Access Compliance Report

Public Rights-of-Way

(Curb Ramps)

Intersection ID: 15838	Main Street: POWDER_HORN_RD	Cross Street: RIDING_TRAIL_RD	Location: SW
ADA ID: 68604144541D	Ramp Type: BlendTrans2	Initial Pass/Fail: Fail	Overall Compliance: No
			Severity Score: 21.25

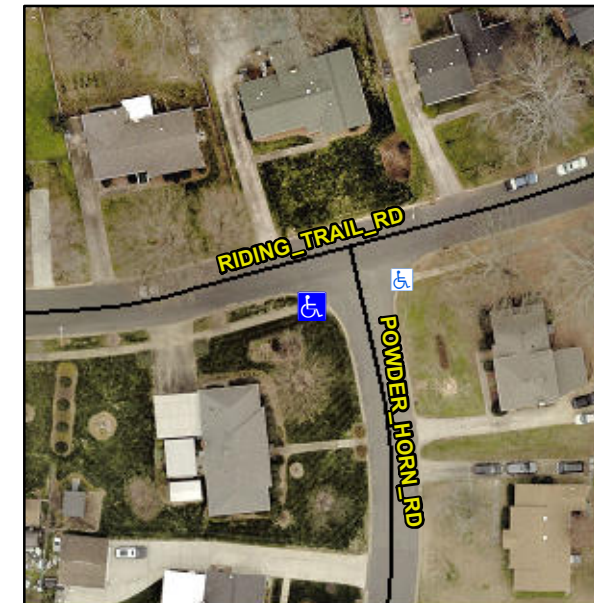
R304.5.1, R304.5.3

Compliance	Description	Data	Compliance	Description	Data
N/A	Ramp Length (in)	40.0	Yes	BlendTrans Slope (%)	1.7
No	Ramp Width (in)	47.5	No	BlendTrans XSlope (%)	5.2
N/A	Flare Type LT	N/A	N/A	Flare Type RT	N/A
N/A	Flare Slope LT (%)	N/A	N/A	Flare Slope RT (%)	N/A
N/A	Flare Traversable LT?	N/A	N/A	Flare Traversable RT?	N/A
N/A	Landing Length (in)	N/A	N/A	DWS Provided?	N/A
N/A	Landing Width (in)	N/A	N/A	DWS Contrast?	N/A
N/A	Landing Slope (%)	N/A	N/A	DWS Length (in)	N/A
N/A	Landing X Slope (%)	N/A	N/A	DWS Full Width?	N/A
N/A	Landing Curb? (Y/N)	N/A	N/A	DWS Offset (in)	N/A
N/A	Shared Landing?	N/A			
N/A	Gutter Ponding?	N/A	N/A	Gutter Slope (%)	N/A
N/A	Gutter Lip Ht (in)	N/A	N/A	Gutter X Slope (%)	N/A
N/A	Painted X Walk1?	No	N/A	Painted X Walk2?	No
	X Walk 1 Direction	To E		X Walk 2 Direction	To N
	X Walk 1 Width (in)	N/A		X Walk 2 Width (in)	N/A
	X Walk 1 Slope (%)	8.3		X Walk 2 Slope (%)	3.6
	X Walk 1 X Slope (%)	1.9		X Walk 2 X Slope (%)	7.3

Remove & Replace Curb Ramp With Two New Directional Ramps or Equivalent.
